# Service Bulletin

**Subject: Nuisance Alarms on H55 and GL-Series Fryers**

**JANUARY 27, 2016**

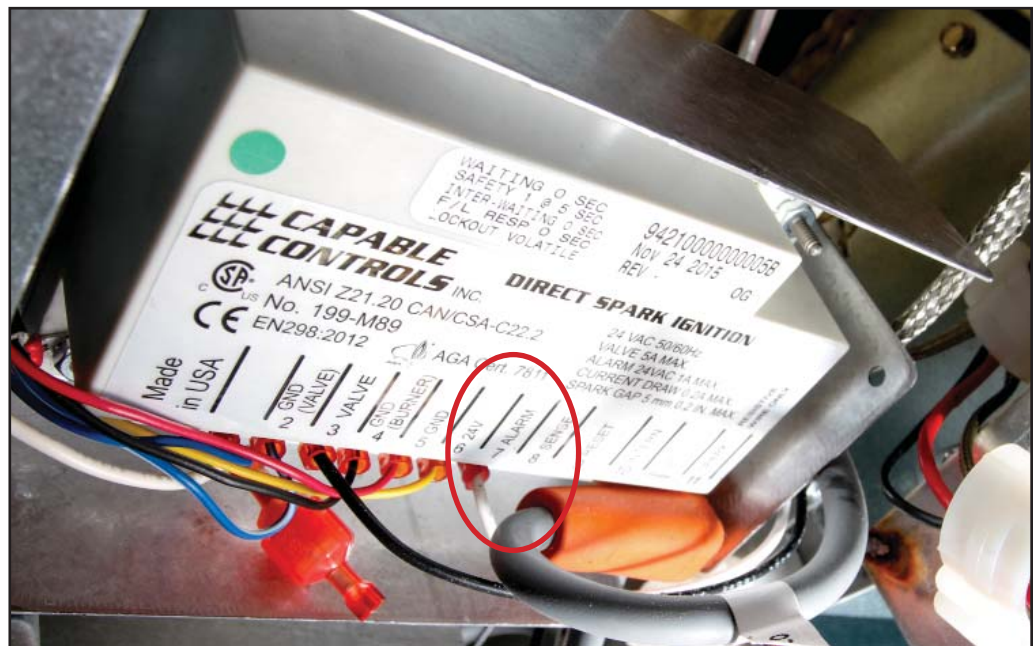
When responding to a HELP, trouble light or Heat Failure display on a high-efficiency H50, H55, LOV, GL30, OCF or FilterQuick gas full-vat fryer equipped with two Capable Controls spark modules, remove the alarm wire connection (number 7 on module) from the left spark module on the troubled vat and all similarly configured vats in the battery.

The left connection on a full vat is redundant and in some controller configurations timing issues between the left and right module can cause intermittent nuisance alarm displays.

The alarm wire (in circle) should be removed on left-side Capable Controls spark modules for full vat H50, H55, LOV, GL30, OCF or FilterQuick fryers with two spark modules. The left-side alarm circuit is unnecessary on single vats with two Capable Controls spark modules. Timing issues between the right and left modules in the alarm circuit can cause nuisance alarms.

The left Capable Controls spark module alarm lead should also be removed on other fryers of the same model and configuration in the restaurant.

**Do not remove** the alarm wire from the left module of a split vat.

The left lead should also be removed when doing service work unrelated to heat issues on these fryer models with two Capable Controls modules per full vat to prevent potential nuisance alarm displays.
